TRANS/WP.29/624
2 June 1998

Working Party on the Construction of Vehicles

DRAFT 02 SERIES OF AMENDMENTS TO REGULATION No. 48

(Installation of lighting and light-signalling devices)

6.5.5.2. or, at the discretion of the manufacturer, for M₁ category vehicles (**):

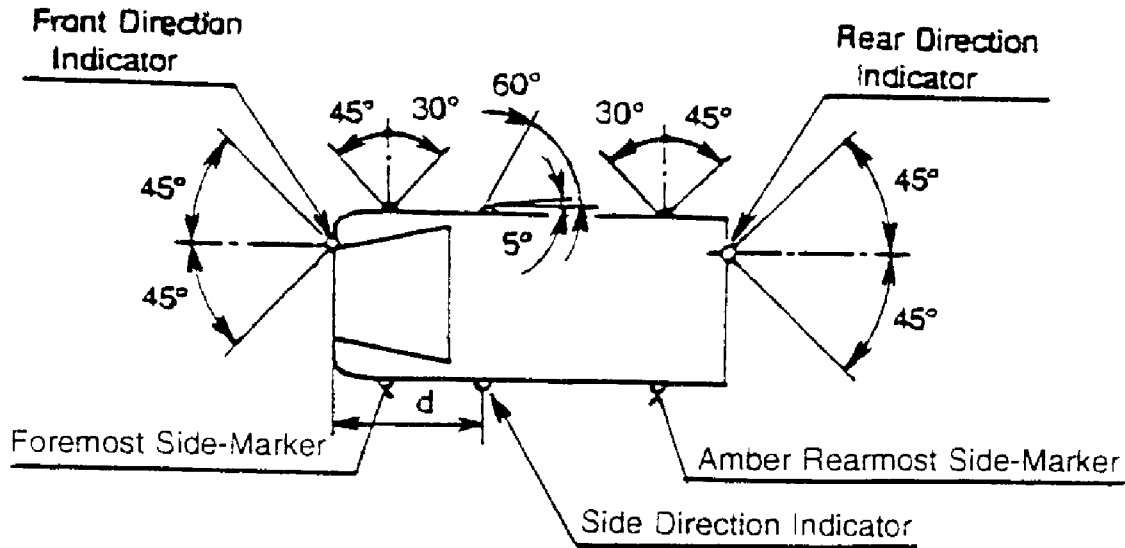
Paragraph 6.5.5., related to Direction Indicator Lamp, amend to read:

Front and rear direction-indicator lamps, as well as side-marker lamps
Horizontal angles see figure below:

(**) The value of 5° given for the dead angle of visibility to the rear of the side direction-indicator is an upper limit

$$d \leq 2.50 \text{ m}$$

Vertical angles: 15° above and below the horizontal. The vertical angle below the horizontal may be reduced to 5° if the lamps are less than 750 mm above the ground.

To be considered visible, the lamp must provide an unobstructed view of the apparent surface of at least 12.5 square centimetres, except for side direction-indicators of categories 5 and 6. The illuminating surface area of any retro-reflector that does not transmit light shall be excluded."
